Placemaking Report

I-90 Allston Interchange Improvement Project

October 2016

Prepared for the City of Boston
Boston Planning & Development Agency

Add I-90 and Soldiers Field Road Connections (Standard #1)

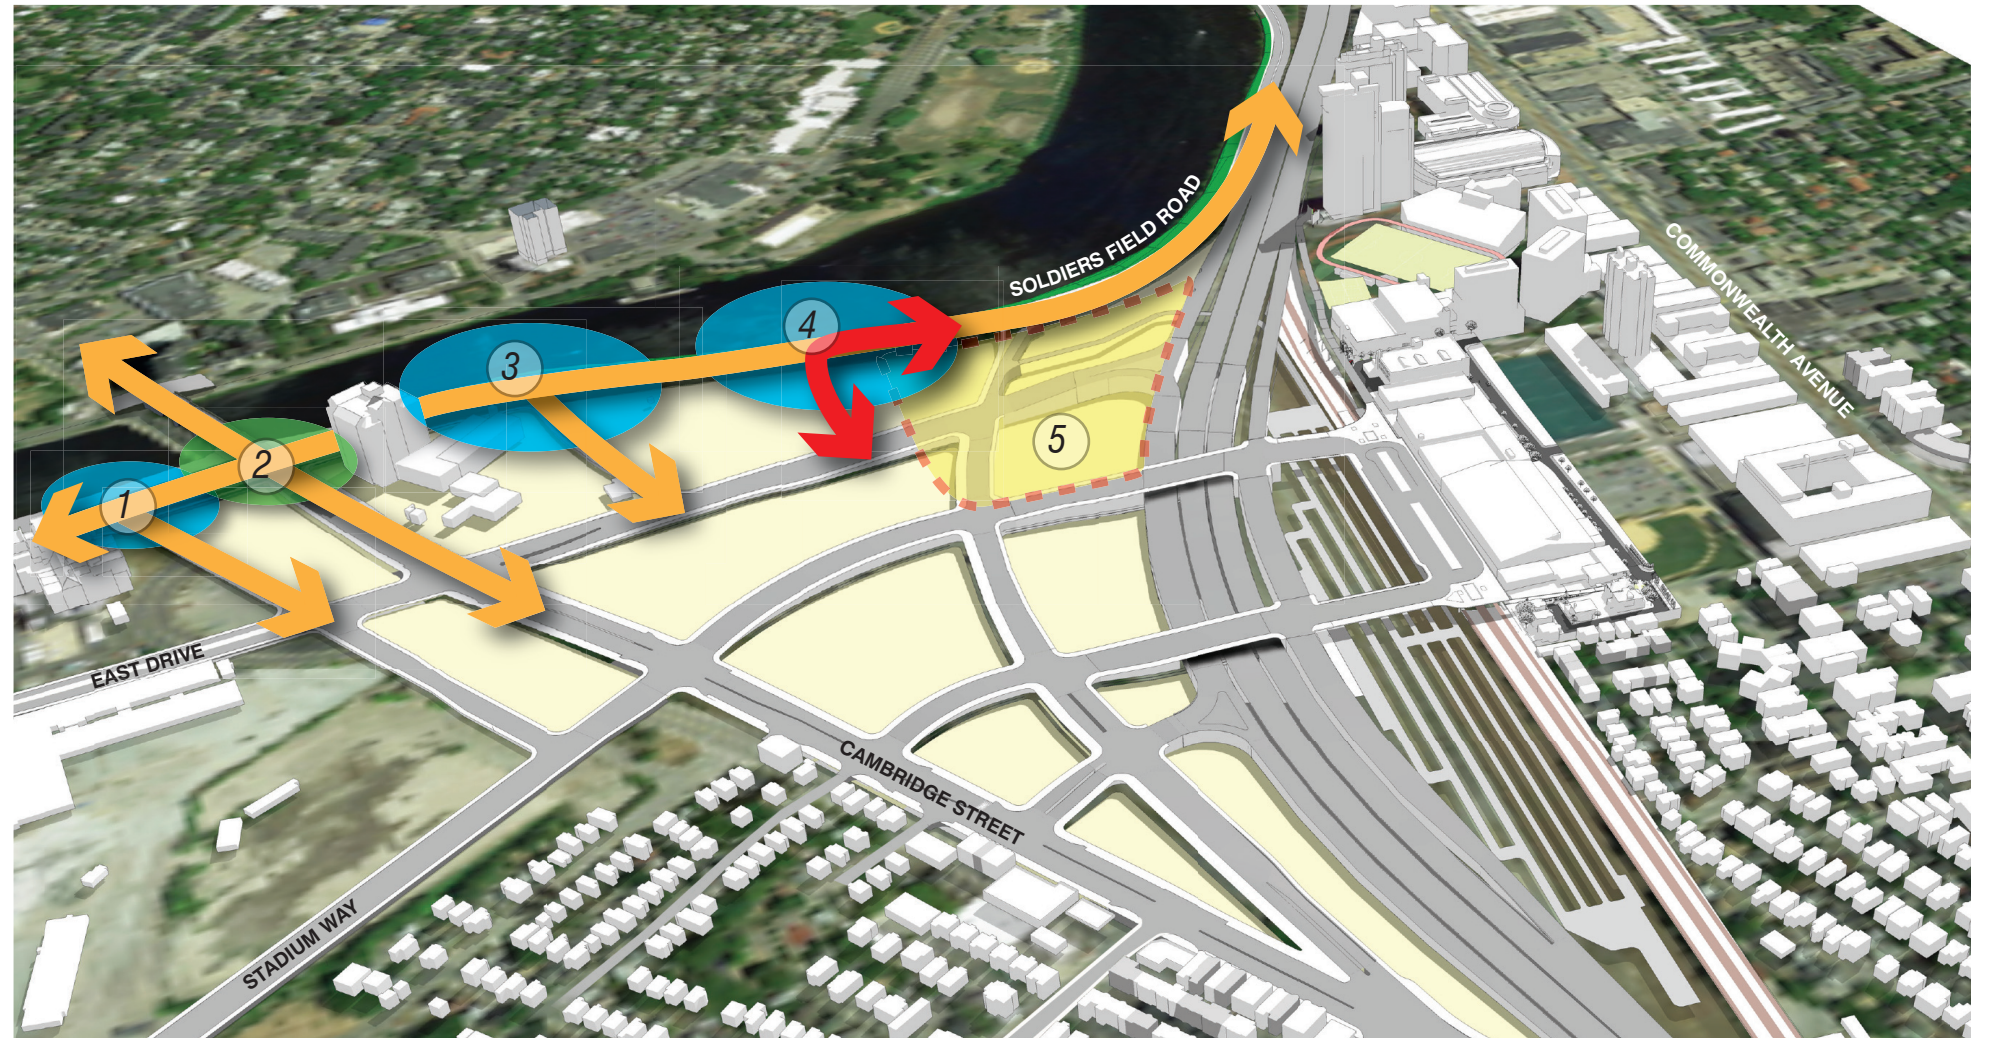
Provide additional access between Soldiers Field Road and the new streets leading to the I-90 ramps in order to reduce traffic on Cambridge Street and support new development.

- Limit the amount of regional traffic using Cambridge Street so that it can be designed and used more effectively as a locally-serving street.
- Reorganize and relocate the connecting ramps to help create a less congested intersection at Cambridge Street.
- Provide more connections into the district to improve connectivity overall, including creating pedestrian and bicycle links and open space to/from and along the River.

There are many benefits associated with creating multiple points of access between the major regional roadway networks, including diminishing conflicts at intersections along Cambridge Street. The major shift from the Alternative 3K-4 would be the realignment of a portion of Soldiers Field Road in a depressed “boat section” so that new ramps and the street system can provide additional access points to and from I-90. This approach also provides better sites and access for future open space and redevelopment. The existing northbound off-ramp from Soldiers Field Road to the River Street Bridge would be removed and traffic re-routed through newly created streets. This would expand the area available for bicyclists and pedestrians along this segment of the Charles River, and further simplify the traffic operations at the congested intersection where Cambridge Street and River Street meet.

1. A new connection from Soldiers Field Road is anticipated in the 3K-4 Alternative.
2. Ramp changes would provide a simpler intersection and provide a wider path for the pedestrian and bicycle link between the bridge and the Esplanade (Paul Dudley White Path).
3. This new connection from Soldiers Field Road that would avoid Cambridge Street is anticipated in the 3K-4 plan.
4. A direct on and off ramp can be created in the general location indicated.
5. Relocating a connecting ramp from the 3K-4 concept will create more flexible opportunities for new development at this constrained corner of the study area.

Realign Portions of Soldiers Field Road Along the River (Standard #2)

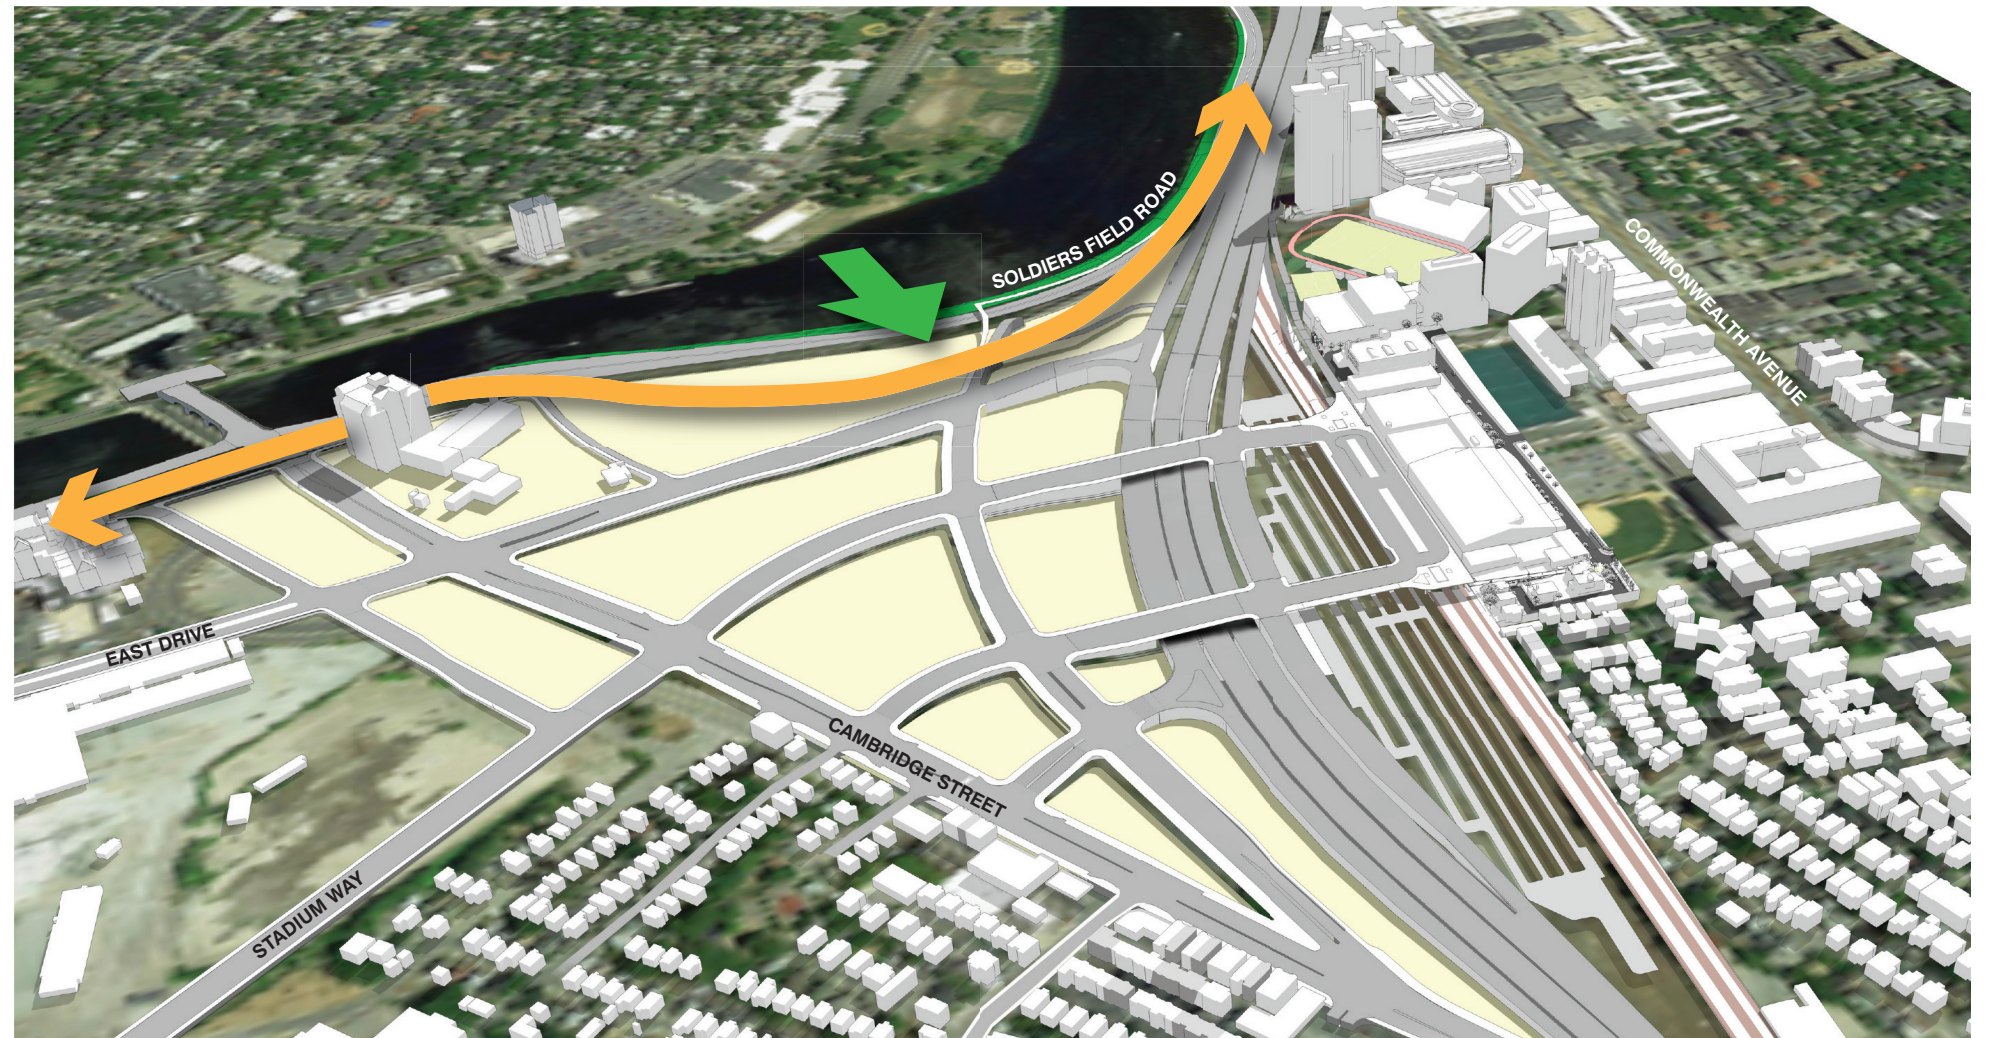
Soldiers Field Road can be pulled further away from the Charles River, creating more useable open space, public access and pedestrian/bicycle connectivity.

- Realignment of Soldiers Field Road should be part of an integrated approach to provide better connectivity to the district, reconfiguring ramps to and from Cambridge Street, and creating more pedestrian and bicycle links between the district and the river in the 3K-4 design.
- The realignment will require designing that section of roadway for lower design or operational speeds.

The realignment of portions of Soldiers Field Road will provide the ability to reorganize the access ramps and unlock open space and public access to the riverfront. The realignment will require the acquisition of property and the active support and coordination with Harvard University and with the Massachusetts Department of Conservation and Recreation (DCR), which is the owner of the Charles River Reservation and the roadway within it. Harvard University and Houghton Chemical have reached an agreement to remove the rail access to Houghton Chemical in two years.

Provide for an Additional East/West Street Connection between Cambridge Street and West Station Area (Standard #9)

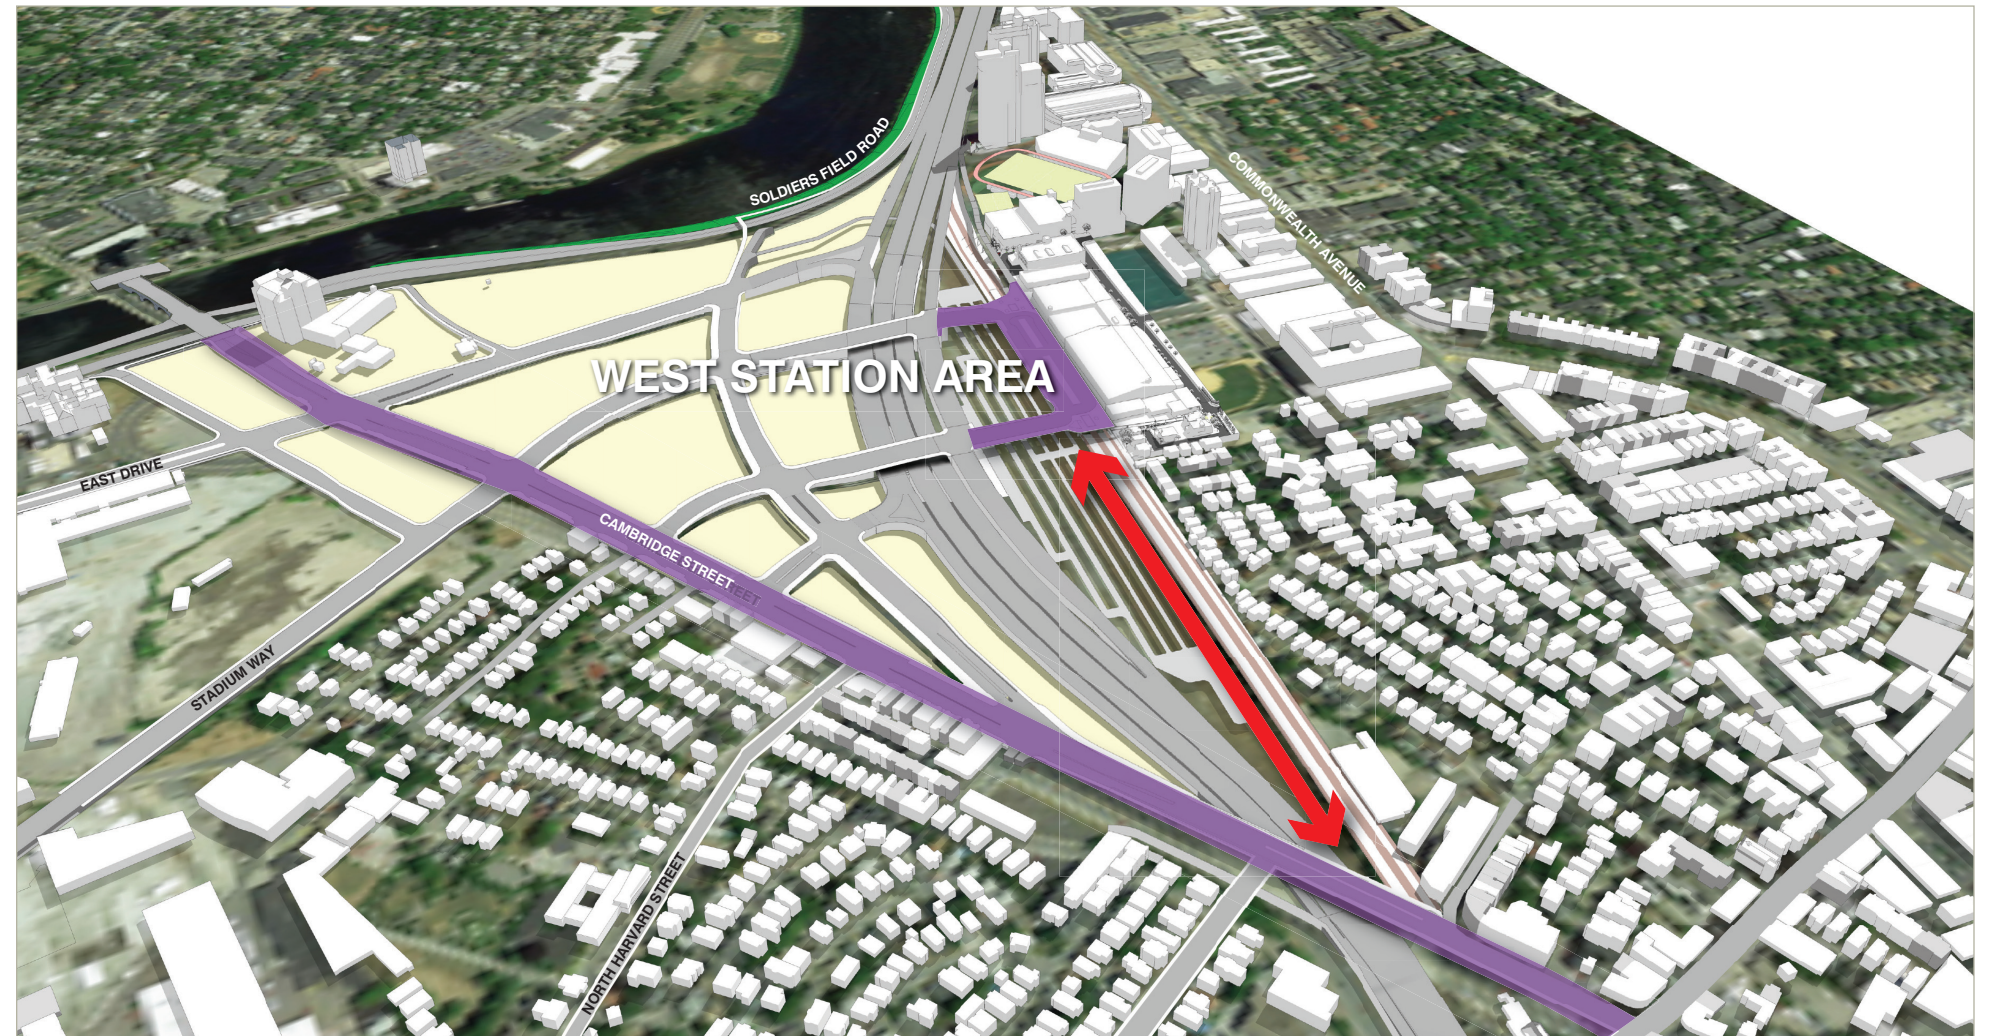
Provide for a direct street connection with bicycle and pedestrian accommodations at or near the Cambridge Street Bridge over I-90 and the West Station area, using air rights.

- This street can provide a more direct connection between the West Station area and areas to the south of the I-90 alignment, reducing the use of Cambridge Street along the edge of the North Allston neighborhood by regional traffic.
- This street should serve pedestrians, bicyclists, and transit.
- This street can become an important connection and frontage road for future air rights development above the rail and highway alignments.
- The new connection should incorporate sound barriers between the neighborhood and the rail/highway infrastructure so that it also forms a buffer.
- Provision of this link should be evaluated further to determine whether it should be included in the initial construction of the Project.

Provide a North/South Link for Shuttles and Buses (Standard #15)

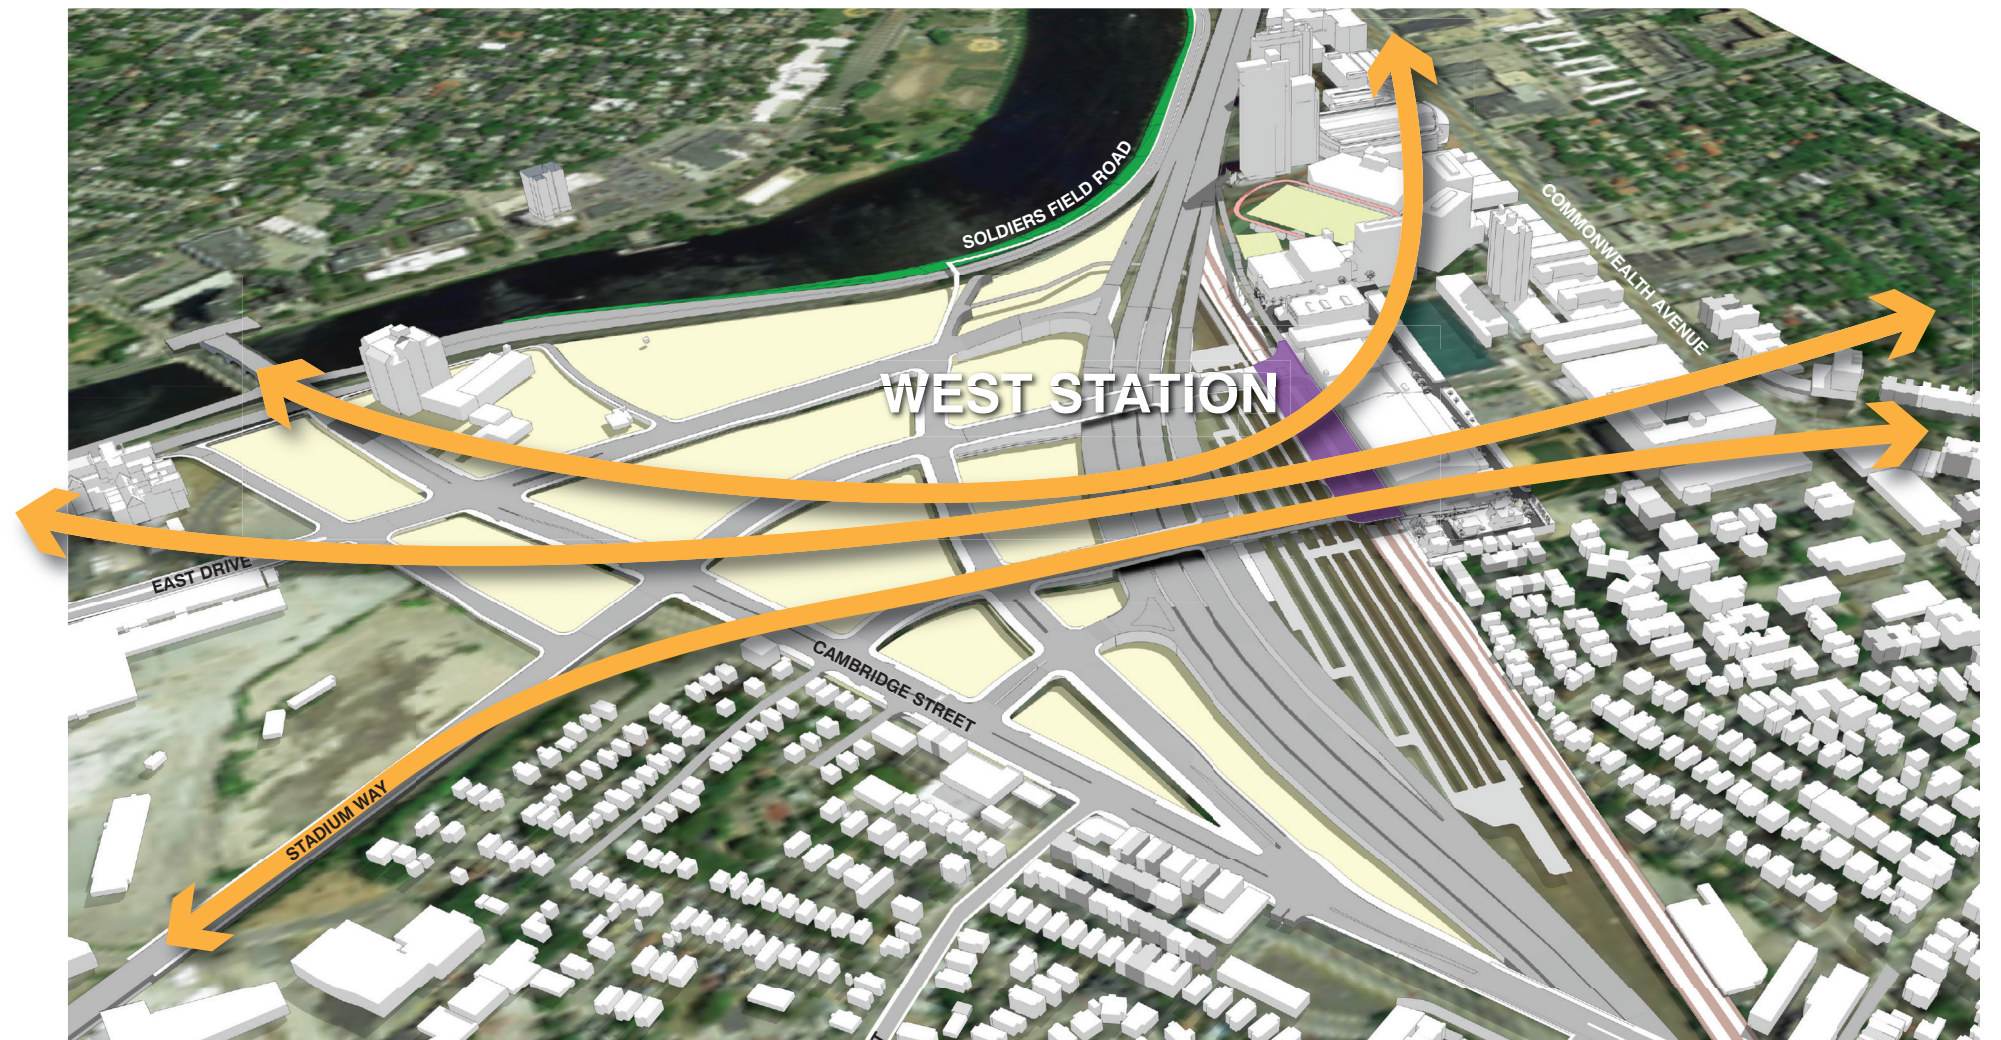
Provide a north/south transit link for buses and shuttles between the North Allston/Harvard Area, West Station, and areas to the east and south, including Kendall Square and the Longwood Medical Area.

- The project should enable bus and shuttle links between the new street network, West Station and areas to the north and south. This is a critical link between major employment centers and the transportation infrastructure. An improved connection will also serve as a critical regional transit link that could help reduce regional vehicular traffic congestion, CO₂ emissions, and potentially the demand for auto trips at this interchange.
- The type and location of these connections will help determine the design characteristics of the West Station area and the spaces and buildings that will be clustered here.
- Routing options could include direct connections to Commonwealth and Brighton Avenues, routing to West Station along Soldiers Field Road and other options.

Various options for the location for such a link have been studied and considered. This urban design standard recognizes that the choice of a route and the design concepts for associated improvements will need to be further studied and documented in the DEIR, but an effective route should be chosen and integrated into the overall project and included in the associated transportation benefits assessments. Any new shuttle and bus connections should be compatible with and enhance ongoing efforts to improve existing transit service, notably the Green Line on Commonwealth Avenue.

This diagram expresses the overall intention to allow for continuous transit routes that can connect multiple transit destinations across the highway and rail corridor, which has blocked north/south links in the past. Routes should be directed past the new West Station. However, there are a limited number of feasible alignments for a transit link, and the most appropriate option will need to be determined as part of the ongoing design and environmental impact report process.
